**FINAL DRAINAGE REPORT**  
for  
**LATIGO TRAILS FILING No. 10**

**AMENDMENT TO MDDP/PRELIMINARY DRAINAGE PLAN  
FOR LATIGO TRAILS**

El Paso County, Colorado

**PCD FILE NO. SF2421**

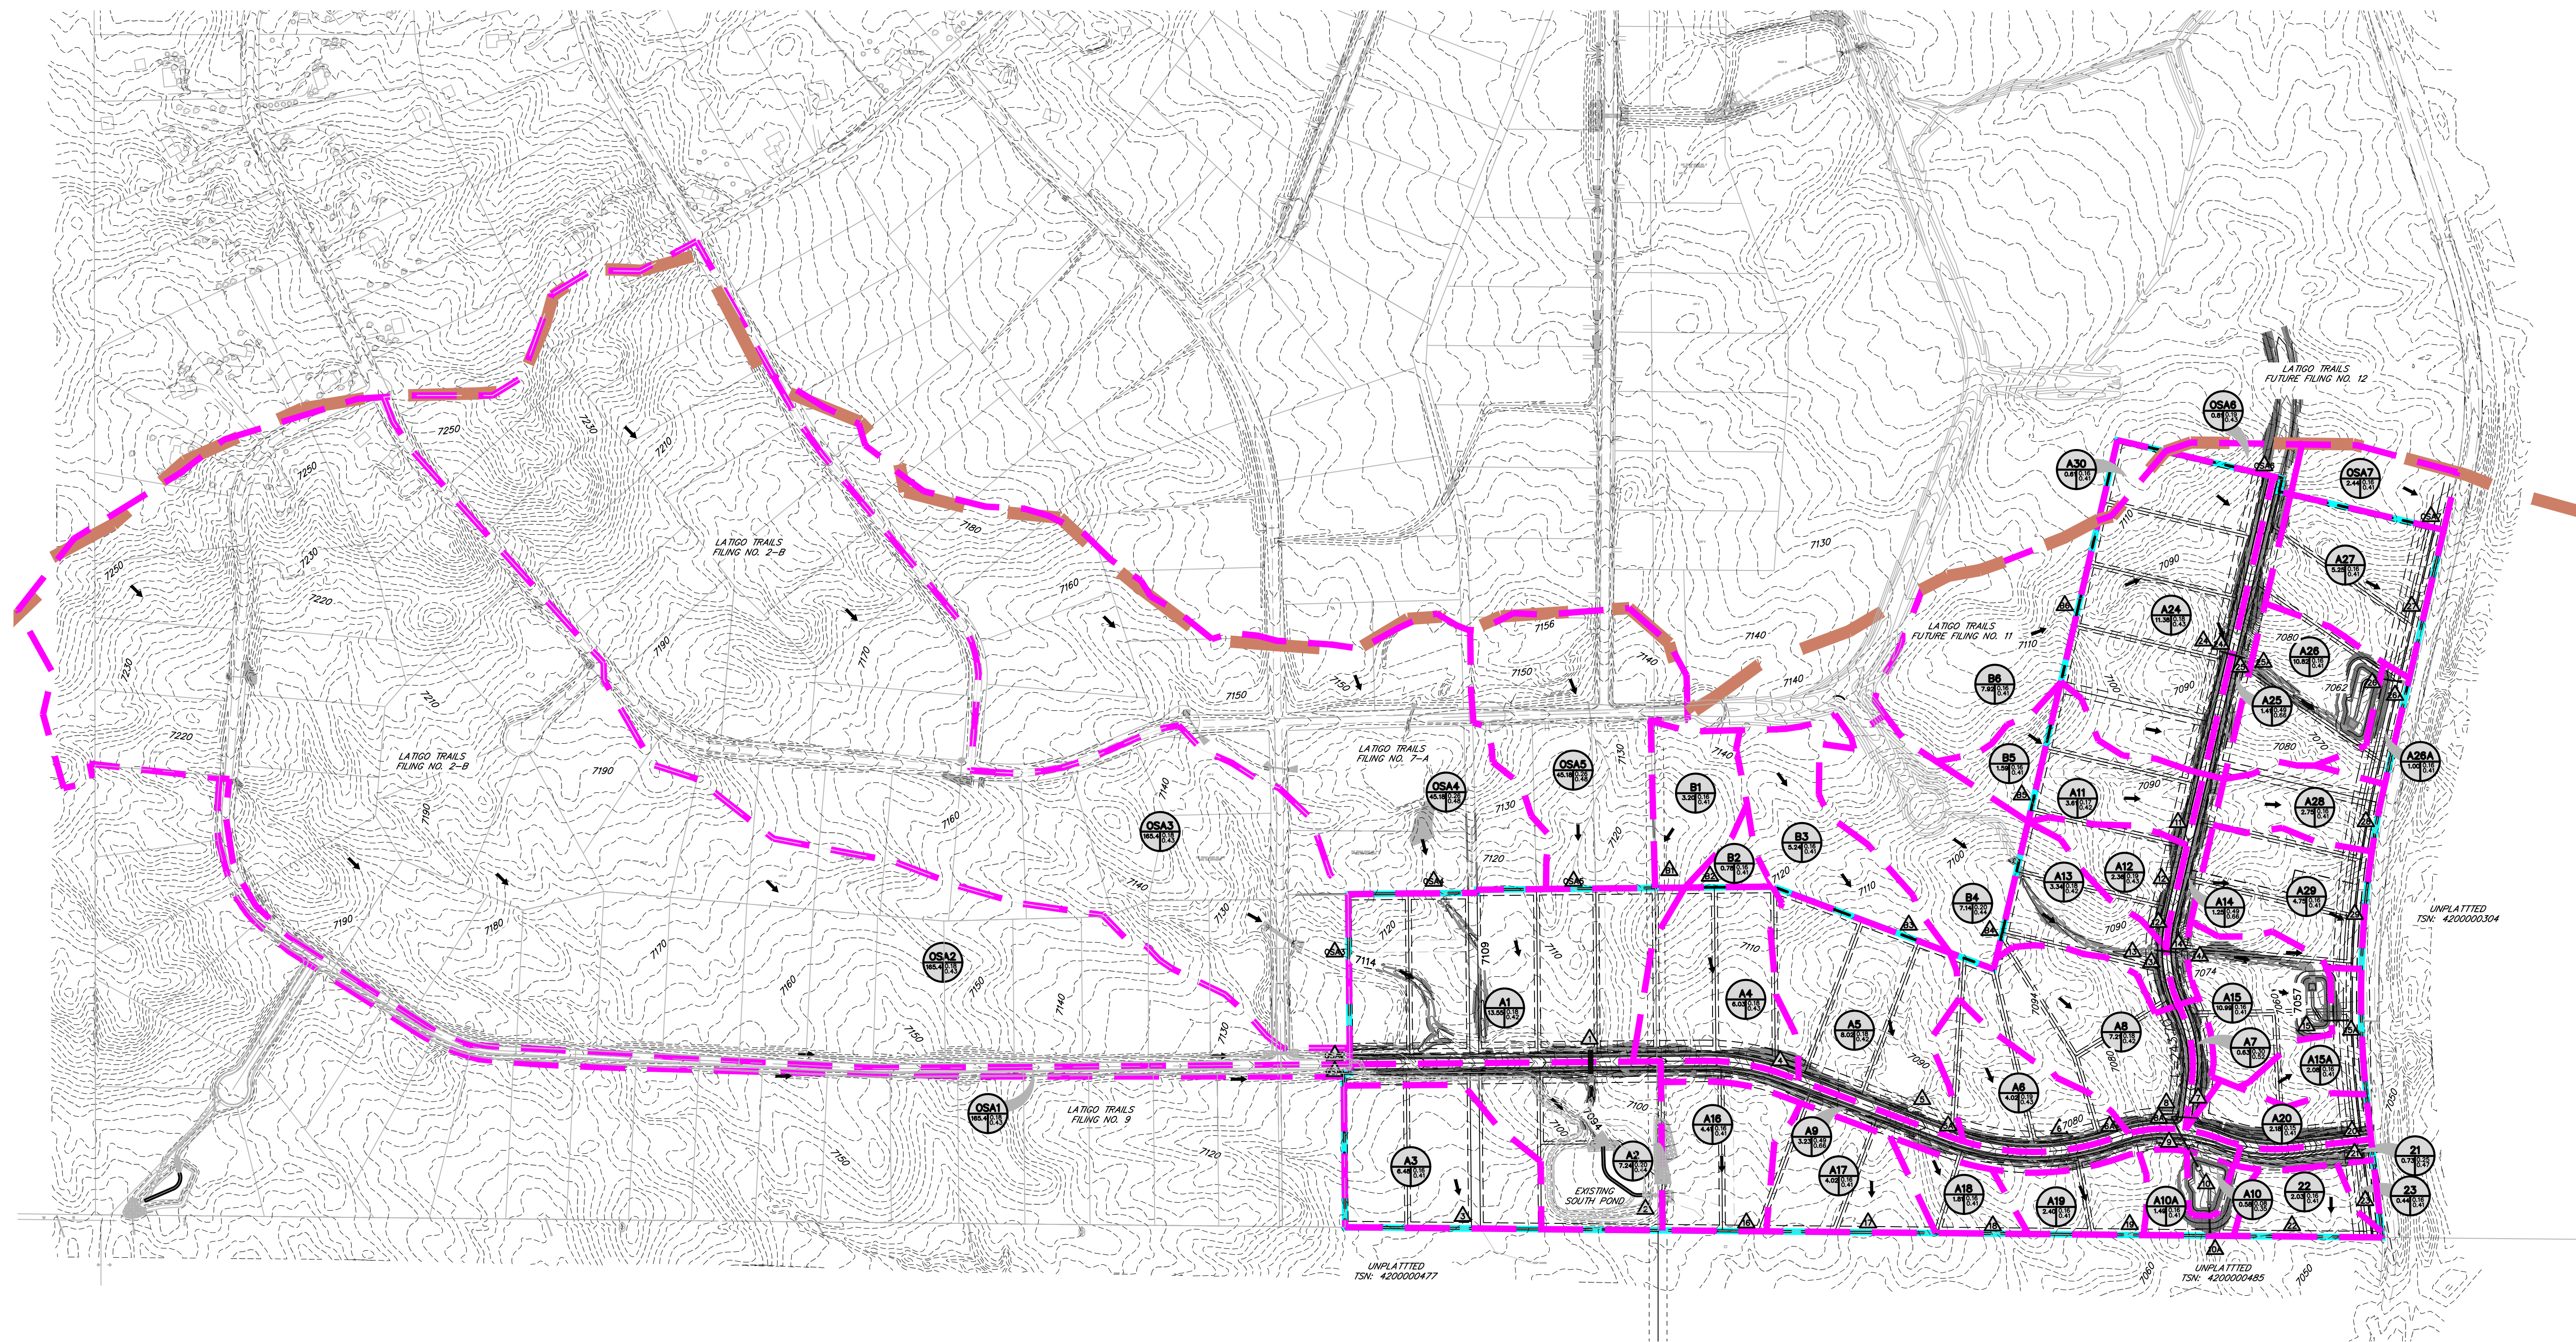
We need to know how much of the proposed area of disturbance (not just the impervious surfaces) is treated vs untreated and if there are any exclusions that apply to the untreated areas. So please create a basic overview map (or modify an existing drainage map) with color shading/hatching that shows areas tributary to each PBMP (pond, runoff reduction, etc.) and those disturbed areas that are not treated by a PBMP, with the applicable exclusion labeled (ex: 20% up to 1ac of development can be excluded per ECM App 1.7.1.C.1 (only if using the WQCV Design Base Standard) and exclusions listed in ECM App 1.7.1.B.#). An accompanying summary table on this map would also be very helpful (2 examples provided):

DEVELOPED  
 FILING 10  
 DRAINAGE MAP  
 PROJECT NO. 21820-01CSCV  
 DRAWING NO.

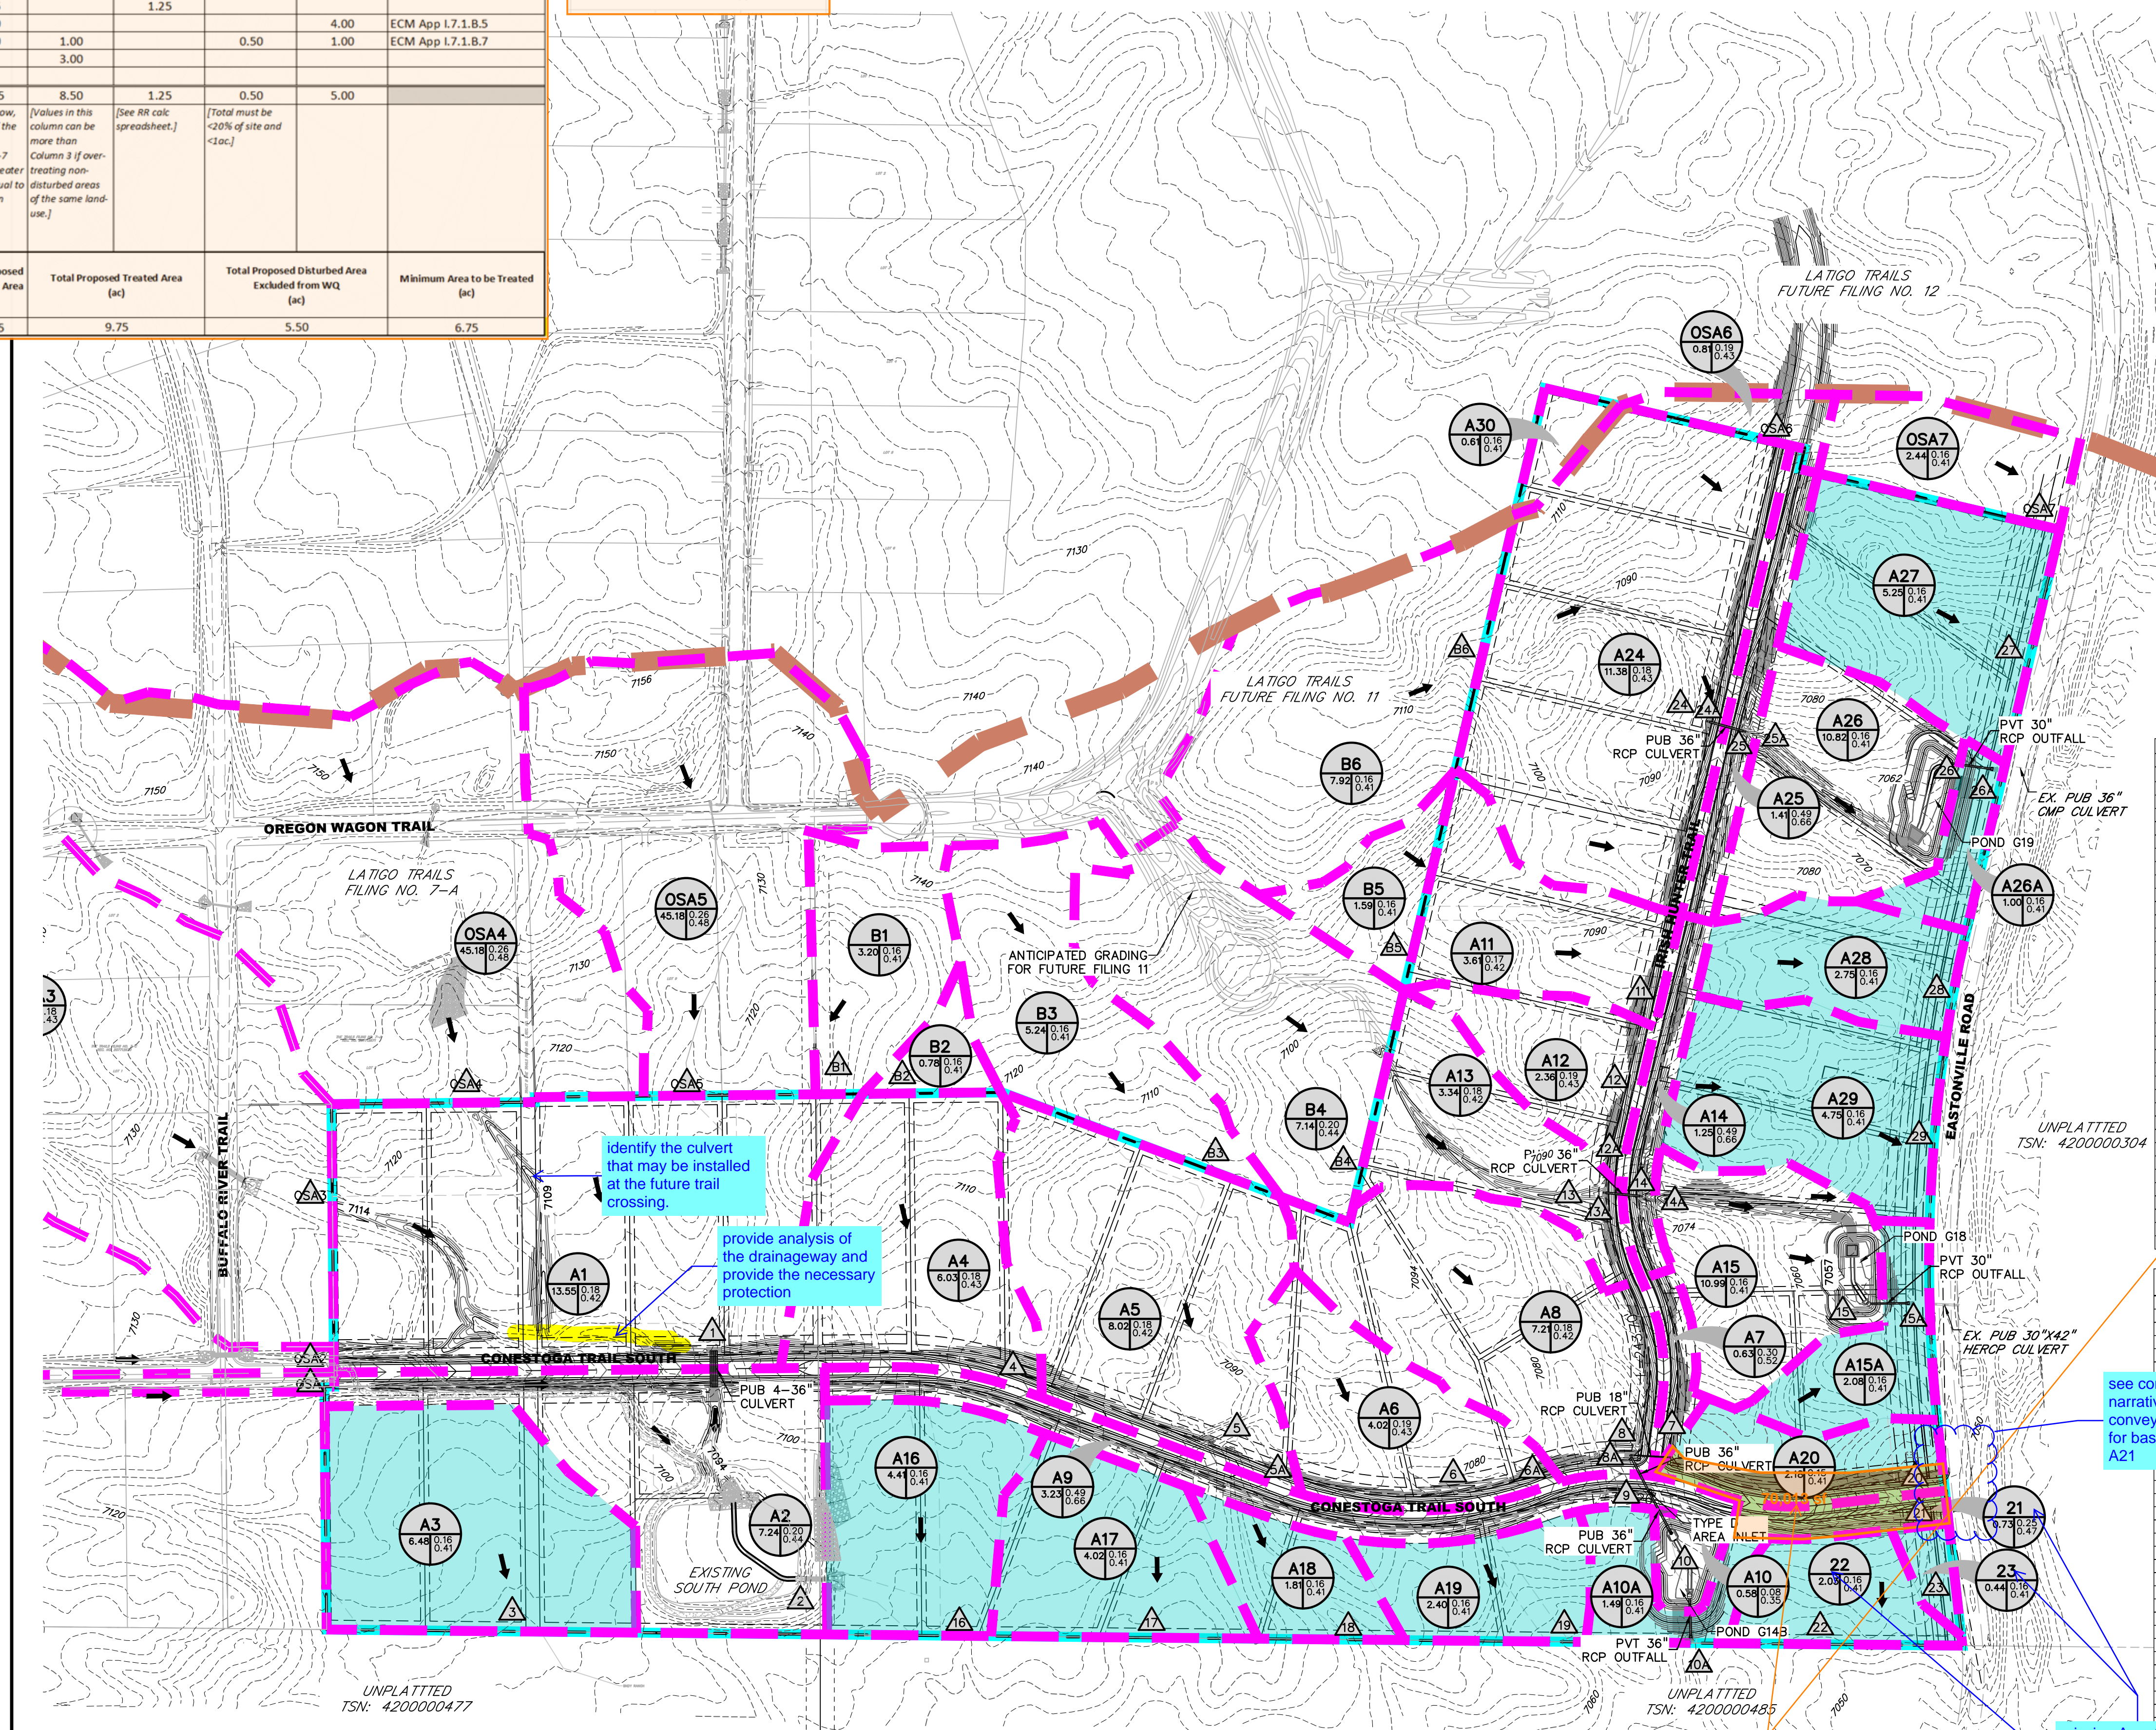
see comment in narrative regarding conveyance of flows for basins A20 and A21
